Discussion of Major Issues Associated With EPA's Compressed Waste Review

General Background on AMWTF Compressed Waste

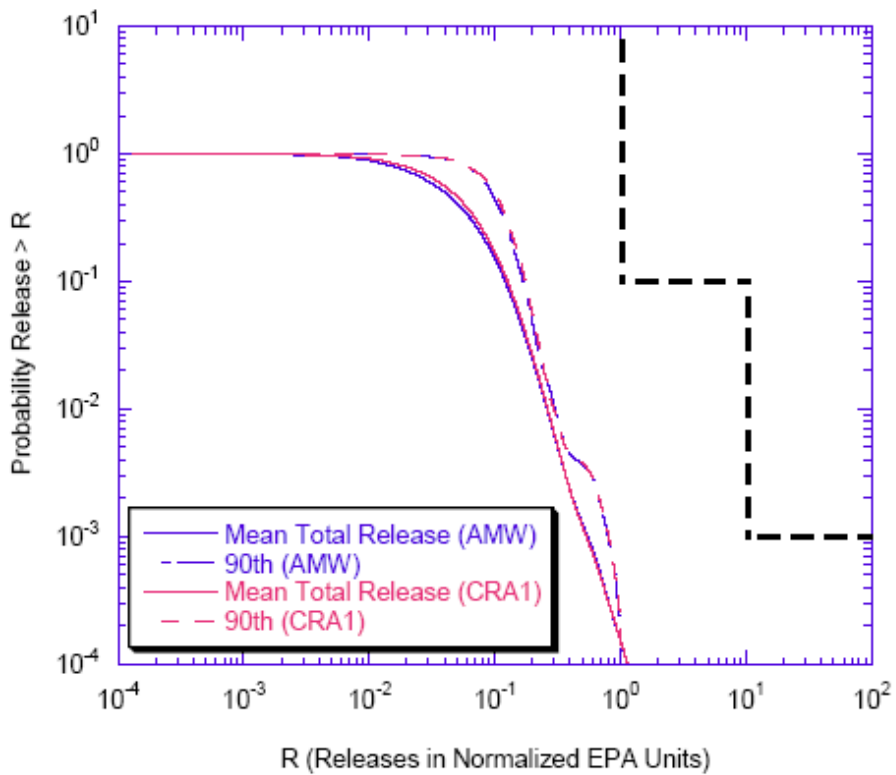
Since the AMW PA inventory and the 2004 CRA use the same inventory, DOE chose to compare the AMW PA with a modified CRA PA¹. In this comparison, the set of CCDF (cumulative complementary distribution function) curves for total normalized releases are almost indistinguishable. The mean total releases and the 90th quantile releases are almost identical. The porosity concerns EPA identified in the review and discussed below should not affect these results because additional analyses showed that important results are not affected by use of constant porosity or porosity surface. EPA's concerns related to the uncertainty are satisfied with a review of the means and 90th quantile of total releases presented in Table 1 and Figure 2.

However, the current regulatory baseline for PA is the PAVT conducted as part of the original certification decision process. As presented in Table 1 the AMW PA releases are lower than the PAVT at the 0.1 probability but higher at the 0.001 probability. While different from the PAVT, the higher releases at 0.001 are not due to AMW PA waste. Instead the differences appear to be due to an increase in cuttings and cavings releases. The cuttings and cavings releases appear higher because a few non-AMWTF waste streams with high radioactivity were sampled.
